Re: SP#488 – Bone and Bark Inn 15 Cannon Road, Wilton, CT

It was a pleasure speaking with you again. Please treat this letter as a request to modify the approved fencing materials for Pen 3 and the Puppy Run as shown on the attached plan – the original plan depicted chain link fencing with sound attenuation material on all sides of the Puppy Run and about 50% of Pen 3, and the proposed plan depicts solid fencing around both pens. As you are aware, Pen 1 and Pen 2 have now been completed with chain link fencing and the sound attenuation material has been installed, and no change is proposed to these areas.

AS PROPOSED

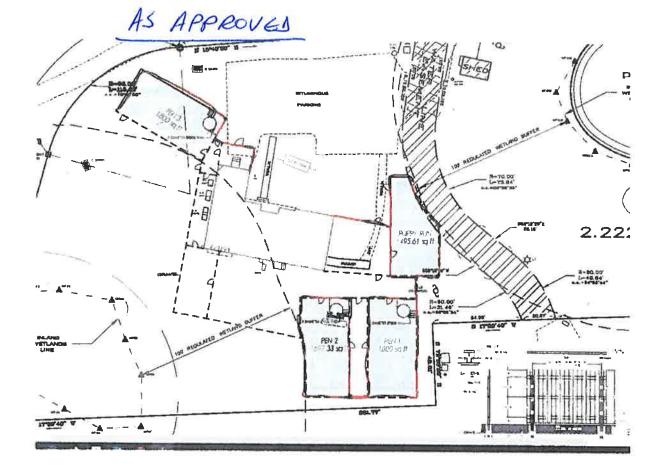
Pen 3 is intended for use by dogs that do not play well with others or otherwise are to be isolated, and therefore it will have limited use and the dogs in this pen are intended to be visually isolated. Similarly, the Puppy Run is intended for puppies and "meet and greet" situations, again with limited intensity of use and with limited stimulus from outside the pen. Both of those areas, and the fencing running across the front, have been constructed using the solid wooden fencing approved by the Commission as shown in red on the attached plan; the visual isolation achieved using the solid fencing limits sound travel and provides a visual barrier so that dogs are not excited by activities in their sight, and this is the appropriate treatment for the animals in these areas. The solid fencing provides the sound attenuation that would otherwise be achieved if the sound attenuation material was installed on chain link fence, and therefore your applicant is requesting that the Commission permit occupancy of these pens for their intended purposes without additional sound attenuation but with the requirement that the solid fencing be maintained. It is notable that with respect to Pen 3 the original plan depicts sound attenuation on only about half of the fence perimeter, so the requested improvements are in some ways a better solution than what had originally been approved.
